No. 4 The Hexagon – Construction Management Plan.

# Construction Management Plan

## RESPONSE TO RESIDENTS ASSOCIATION COMMENTS

Drawing:  
**160128-03**

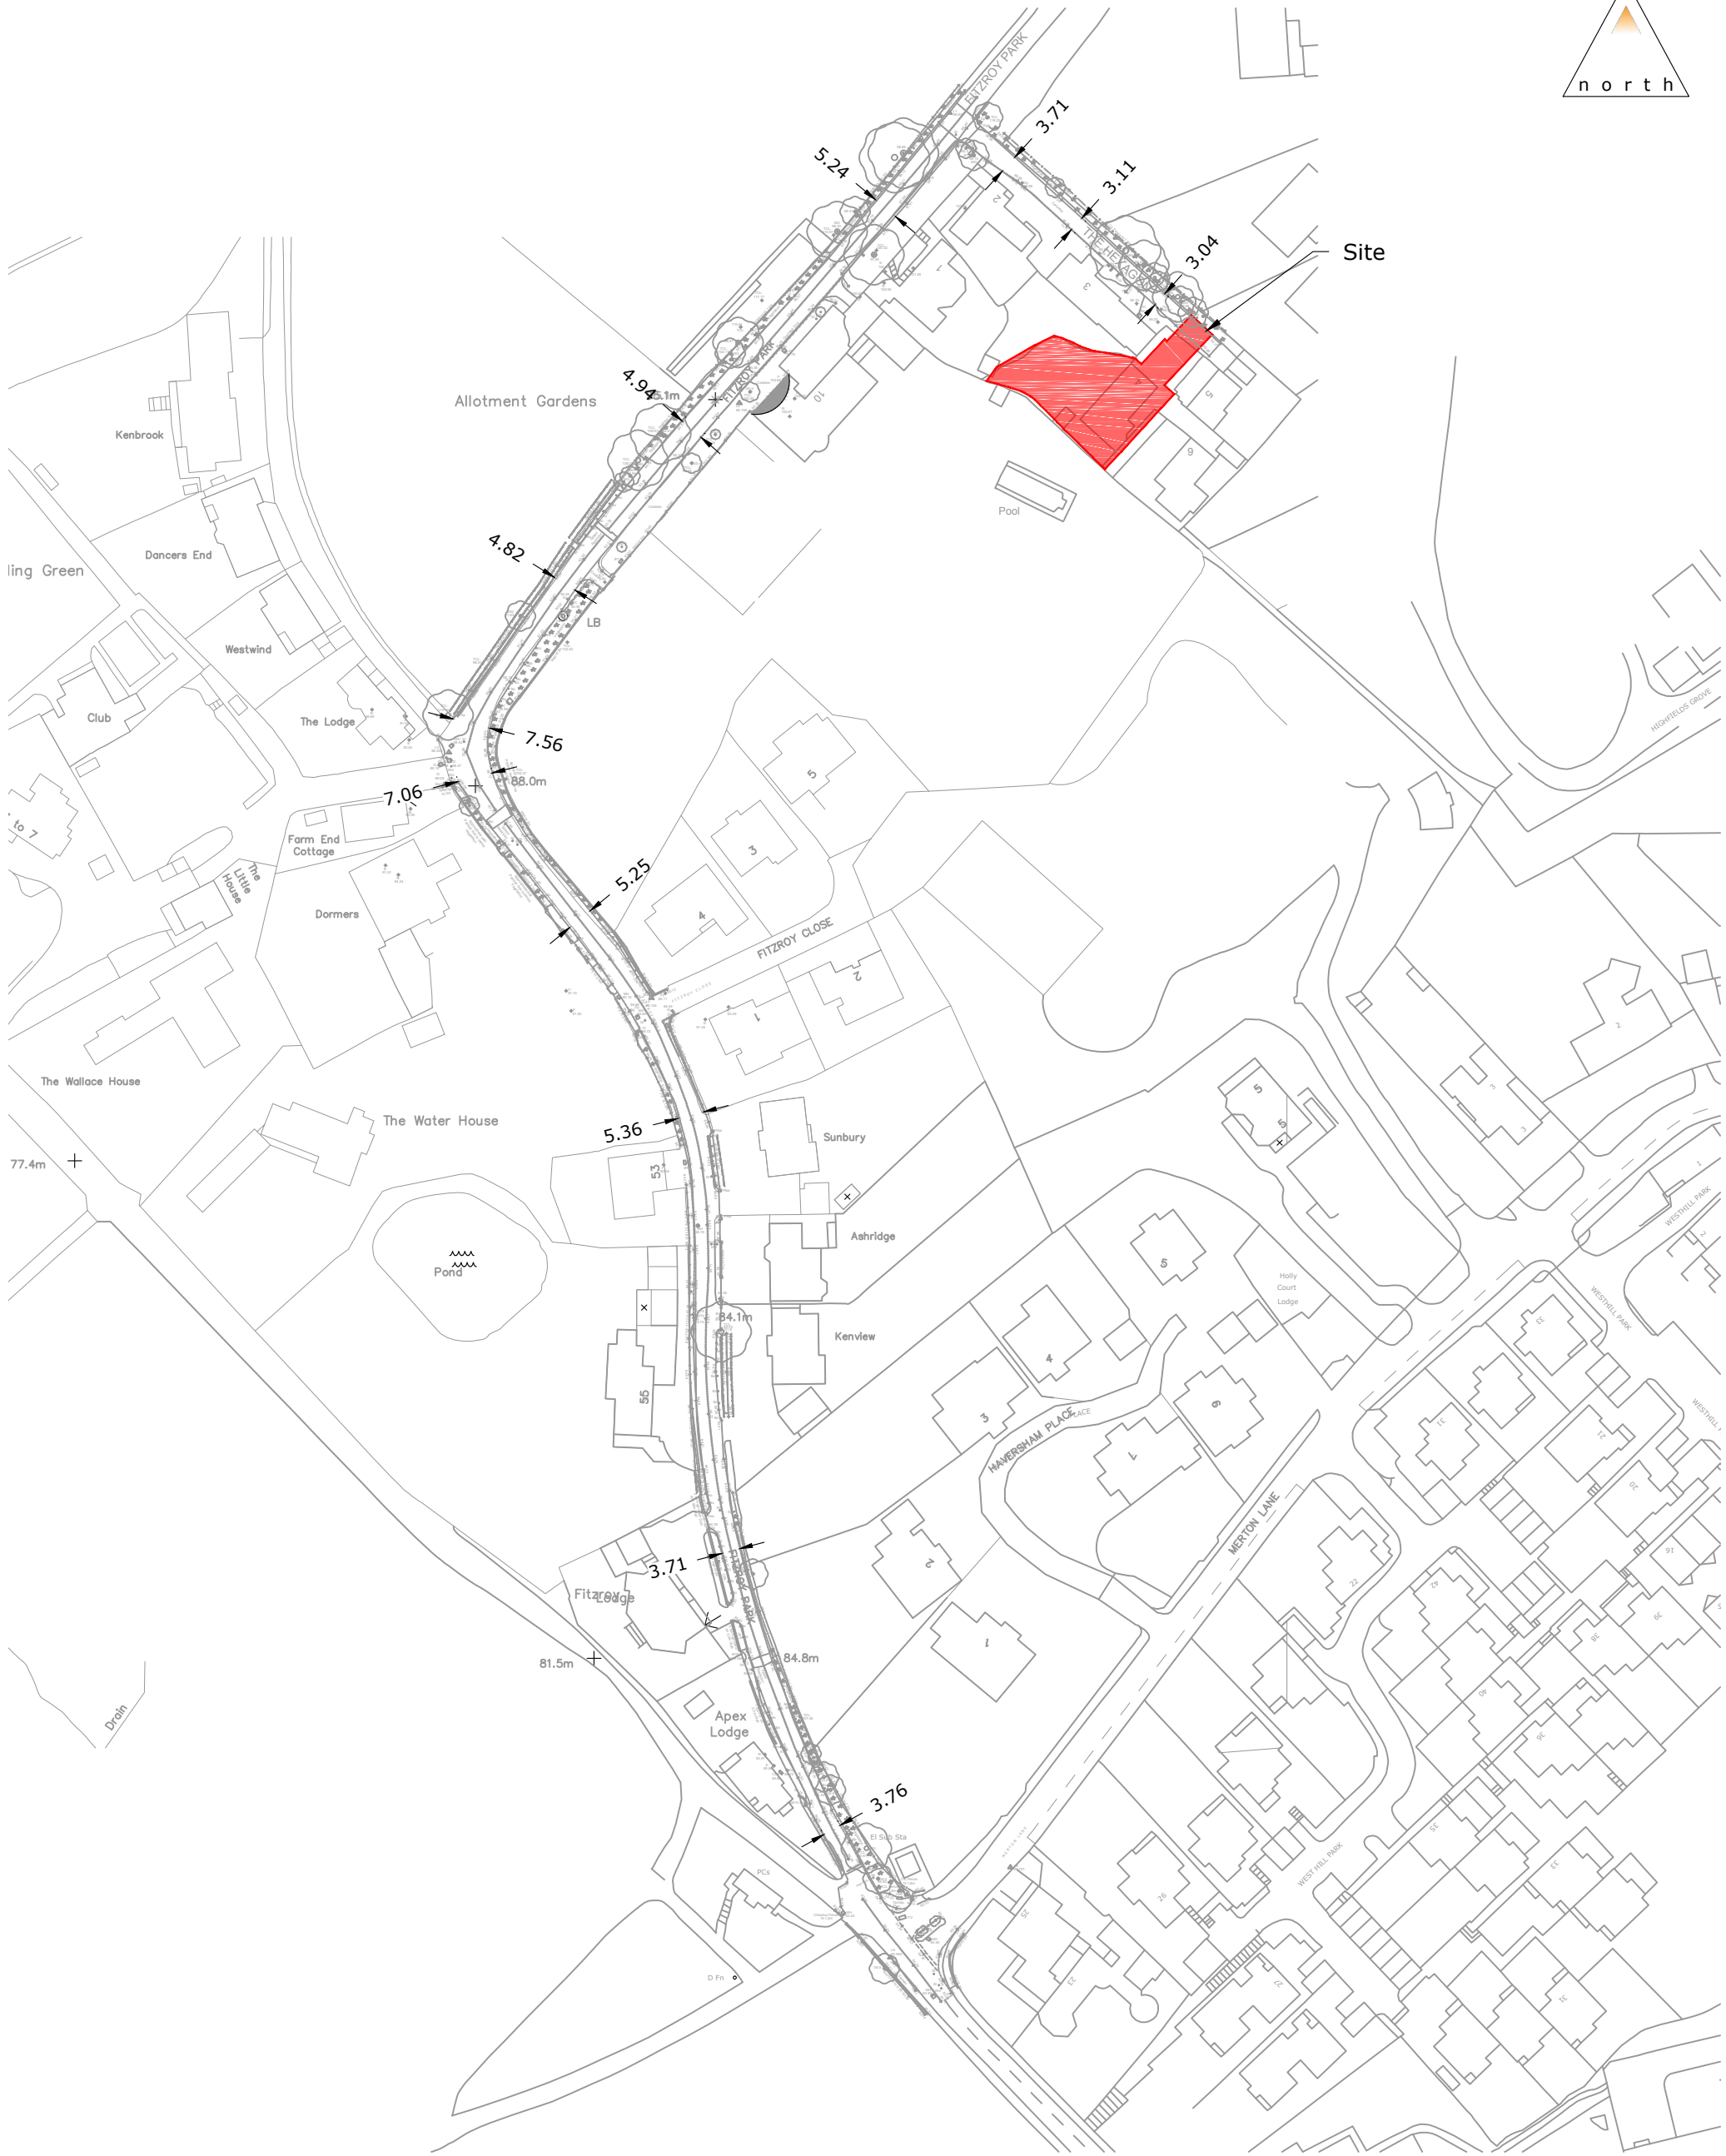
Given very limited width of Fitzroy Park at various pinch points - at T-junction and 3-way junction - please provide SWA showing how HGVs will negotiate these turns with cars parked. I measured the width with a van parked by the post-box and it was only 2.5m - not wide enough for HGVs. If HGVs cannot pass then please show clearly how many car parking 'bay suspensions' will be needed and where.

The topographical survey has been used to determine road widths. To be robust, we have assumed that a 2.5 metre wide vehicle could be parked at the edge of Fitzroy Park. Where Fitzroy Park narrows to below 5 metres, 'parking suspensions' will be put in place and residents will be notified of their locations and hours of operation. The location of 'parking suspensions' is shown in Drawing **160128-03**.
